AMENDED FINAL DEVELOPMENT PLAN

FOR JIMMY JOHN'S

121 SOUTHGATE DRIVE
GEORGETOWN, KENTUCKY 40324
(AMENDS FDP APPROVED 08/2020)

SUMMARY OF AMENDED PLAN CHANGES

AMENDED PHOTOMETRIC PLAN

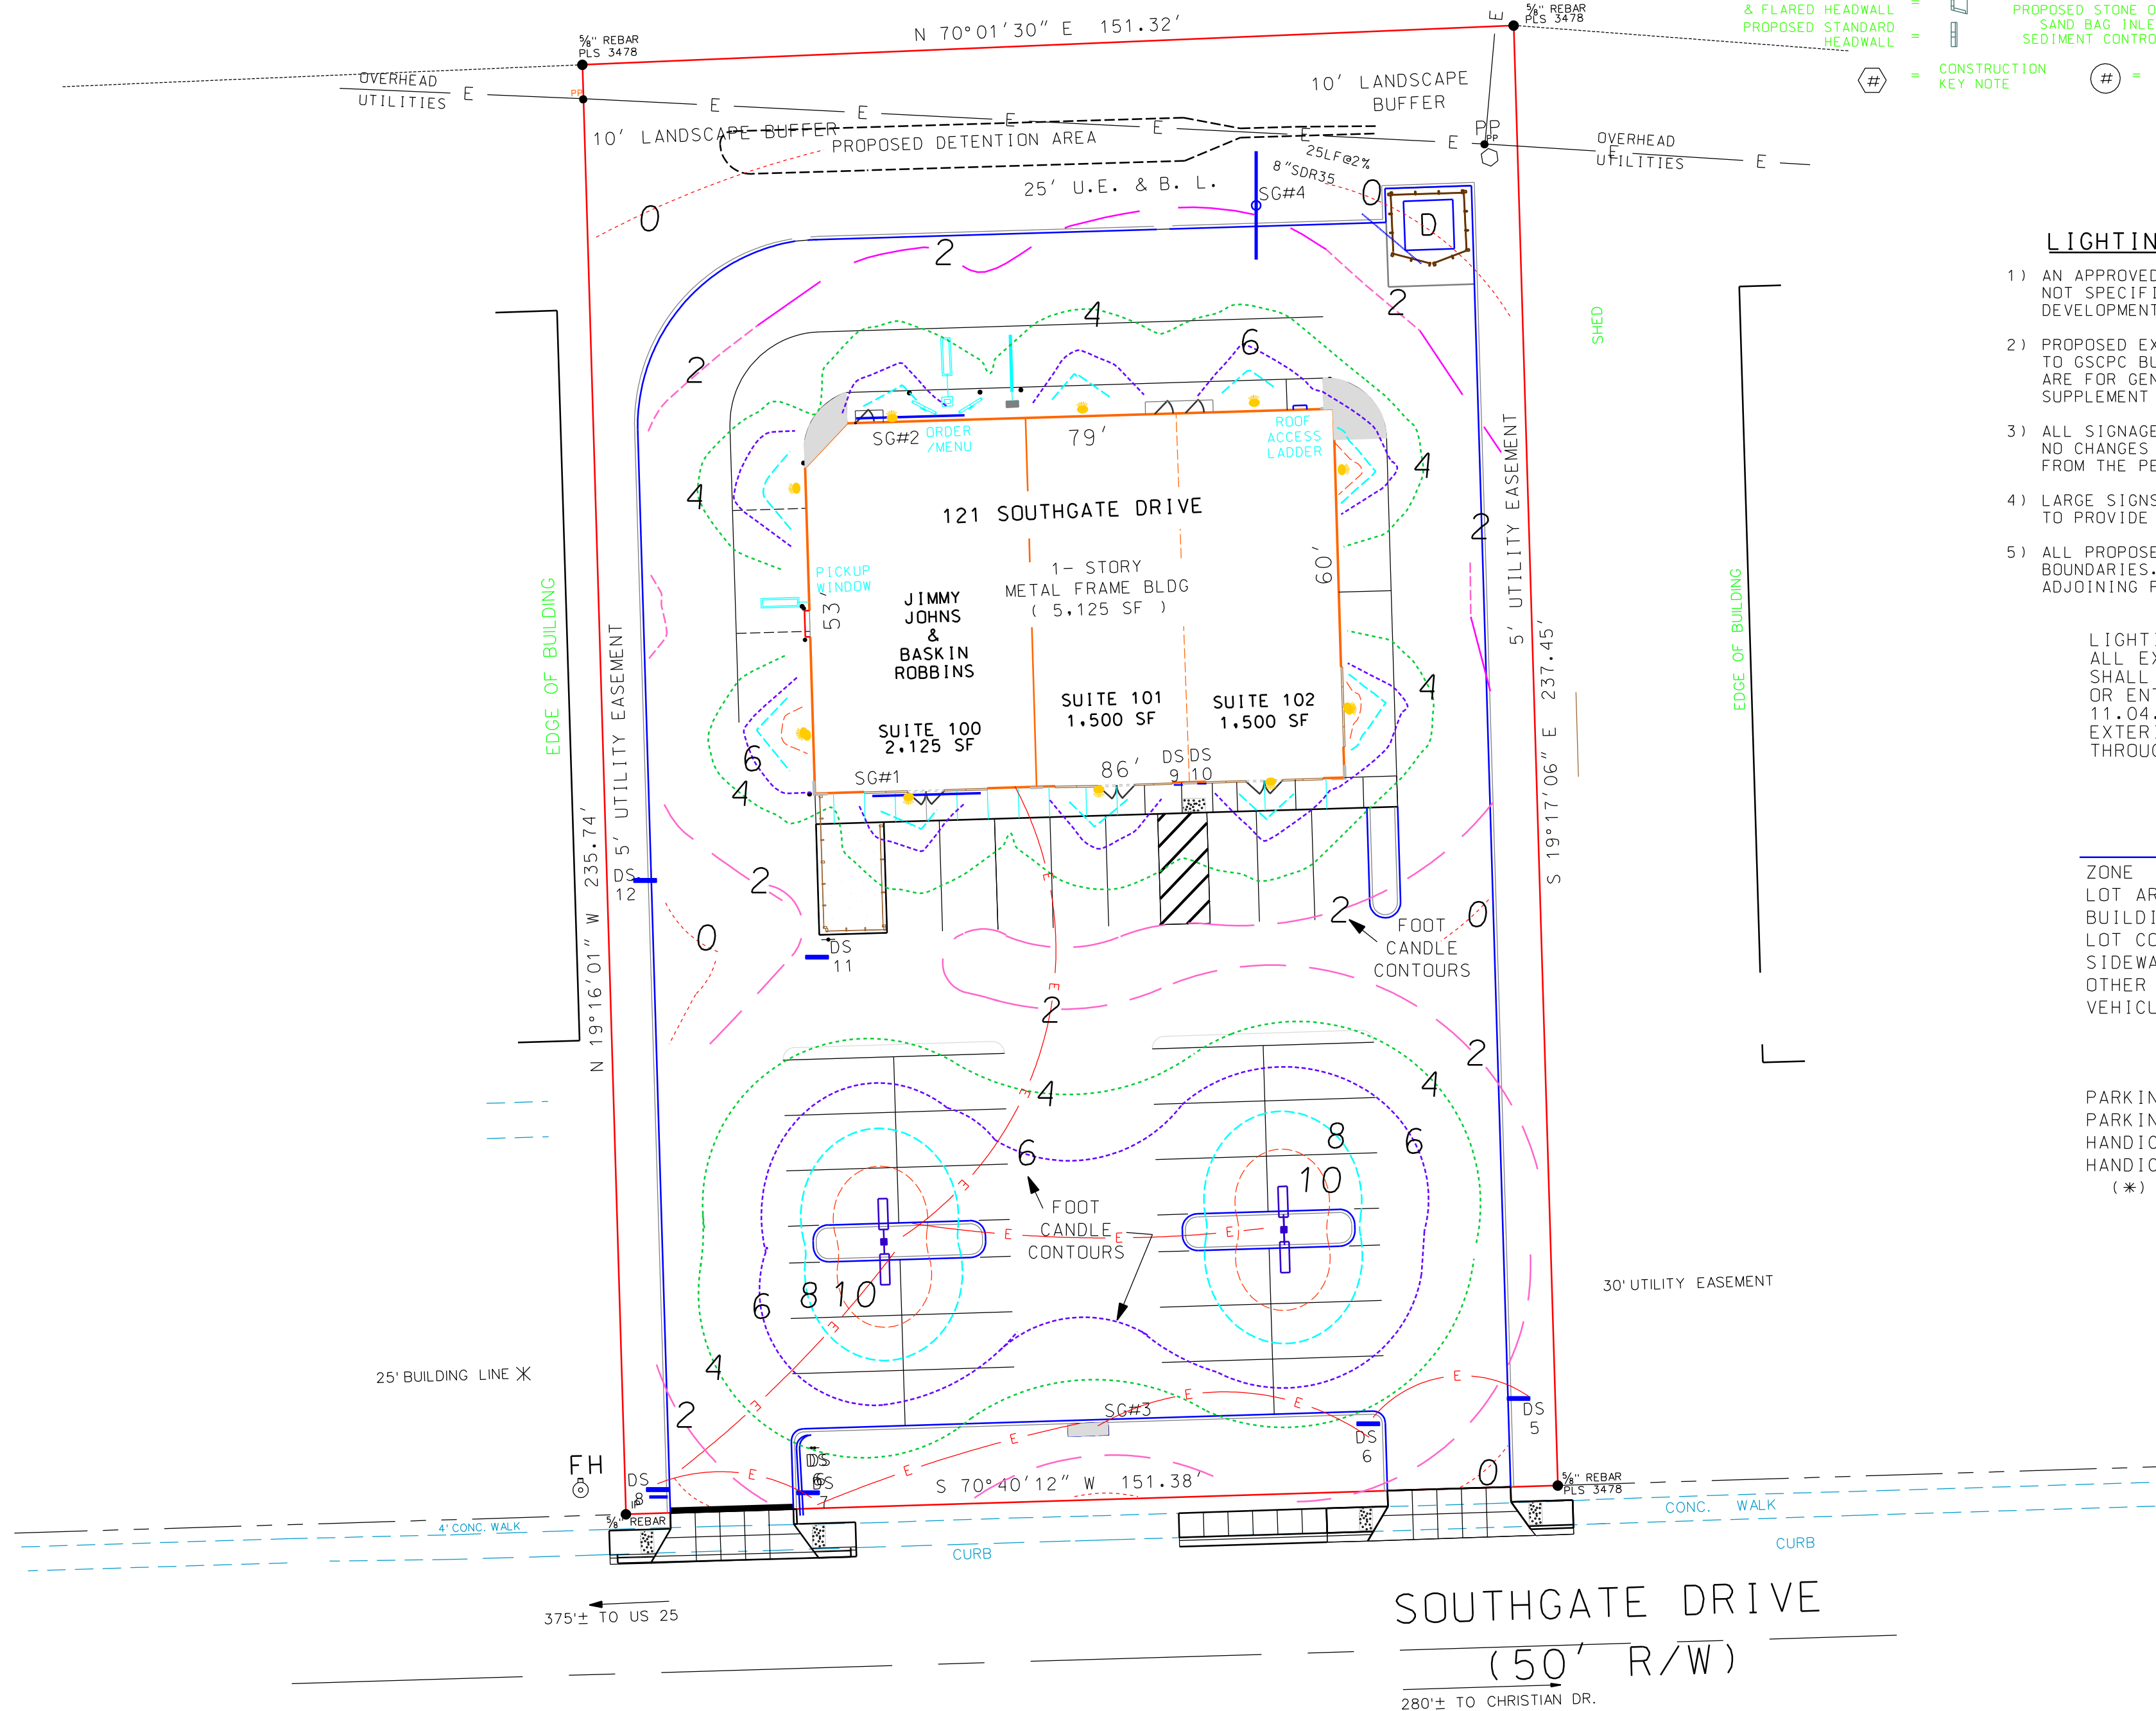
- 1) REVISED PLAN FOR NEW ISLAND LOCATIONS.
- 2) ADDED LIGHTS TO FRONT OF BUILDING FOR GREATER ILLUMINATION AT UNIT ENTRANCES.
- 3) REVISED PHOTOMETRIC PLAN IS BASED ON PREVIOUSLY APPROVED PLAN BY LIGHTING SUPPLIER.
